DAVE BAXTER
Vice President
Oconee Nuclear Station

Subject: Duke Energy Carolinas, LLC
Oconee Nuclear Site, Units 1, 2, and 3
Docket Numbers 50-269, 50-270, and 50-287
License Amendment Request for Approval to Mitigate Alloy 600 Concerns in the
Oconee Pressurizer
License Amendment Request (LAR) No. 2008-08

EVALUATION OF PROPOSED CHANGE

UFSAR MARK UP

OM 2201.-3220 001

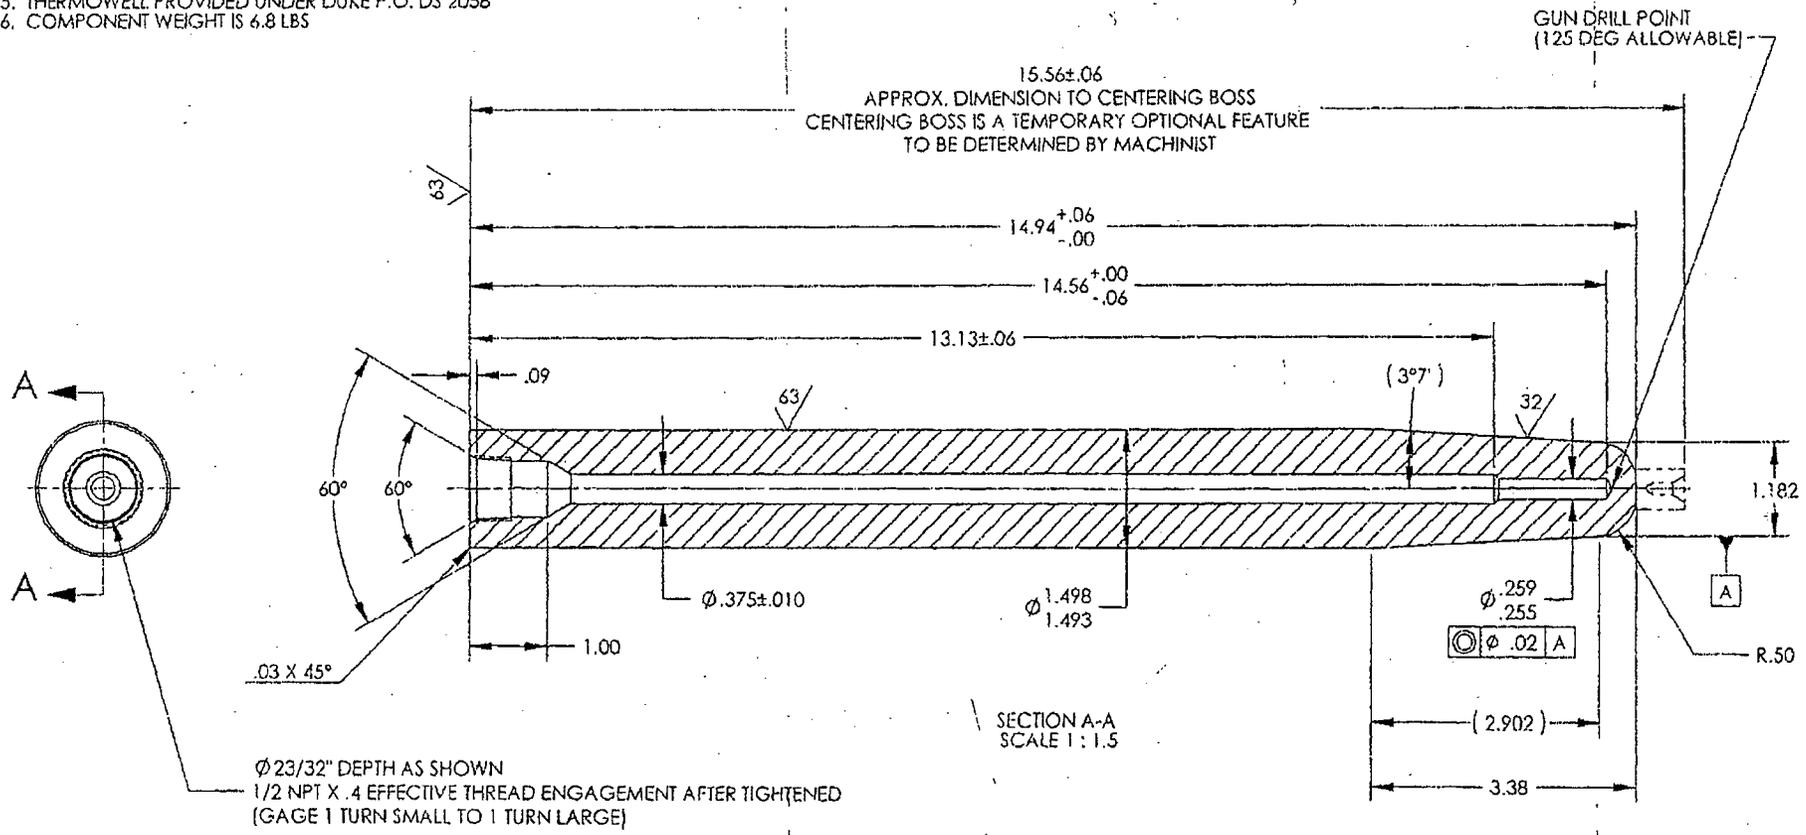
The replacement Pressurizer thermowell leaves a small area of the Pressurizer shell CS exposed to the Pressurizer water space environment. The ONS Unit 1 shell material is SA212, Grade B and the ONS Unit 2 and 3 material is SA516, Grade 70. The exposed area is of a cylindrical geometry, with a 1.510” maximum diameter through the 6.188” Pressurizer shell thickness, resulting in an exposed area on the order of 30 sq in. The new Alloy 690 thermowell has a 1.493” to 1.498” outside diameter, so the radial gap between the new nozzle and Pressurizer head bore diameter is a maximum of 0.0085”.
